FACILITY NAME (1) CRYSTAL RIVER UNIT 3	DOCKET NUMBER (2) 05000302	PAGE (3) 1 OF 08
--	--------------------------------------	----------------------------

TITLE (4) **BROKEN STEM NUT IN "B" FEEDWATER MAIN BLOCK VALVE RESULTS IN A FEEDWATER TRANSIENT AND SUBSEQUENT REACTOR TRIP**

SPECIAL ATTACHMENT TO LER 88-006

ABBREVIATIONS USED IN THIS DOCUMENT AND ON LER 88-006 FIGURE 1:

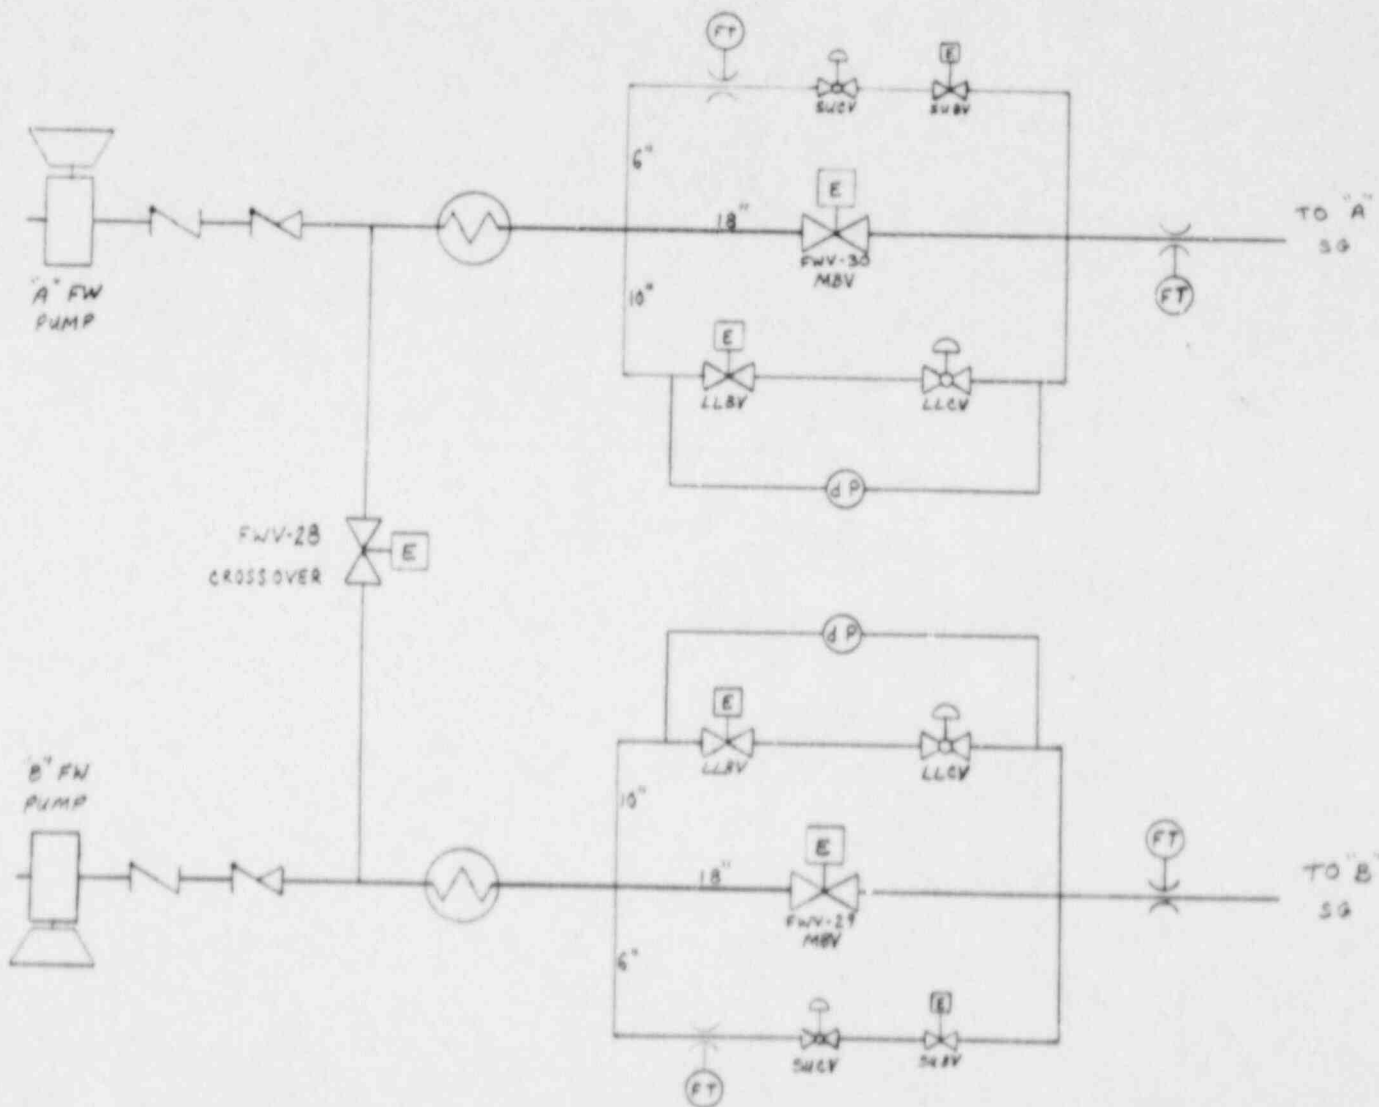
5. Q - Provide P&ID's for the MFW system and ICS system schematics.
A - Figure #1 of LER 88-006 shows the arrangement of the FW valves. Item #1 describes the ICS control of FW from 0% to 100% power. Additional drawings have been provided to the Project Manager.
